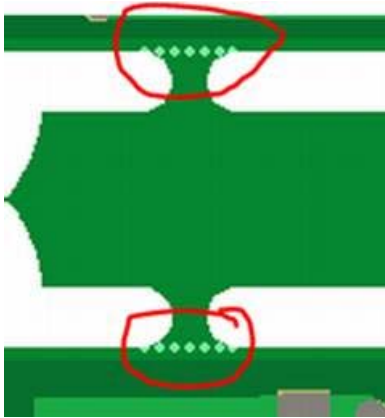
Some points to check :

- Is there some little holes to help breaking the holds ? I can't see them in the drl file :

- Why do you use a 2nd file ? Is it a drl file ? If yes, why not putting them in the drl file ?

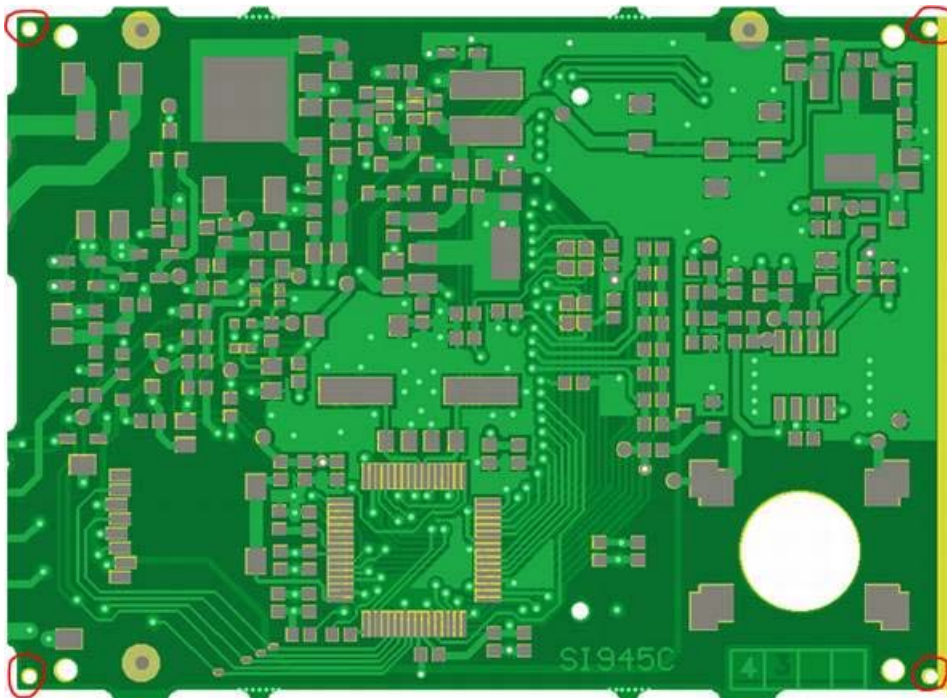
- Why are those 4 holes not in the drl file ? :
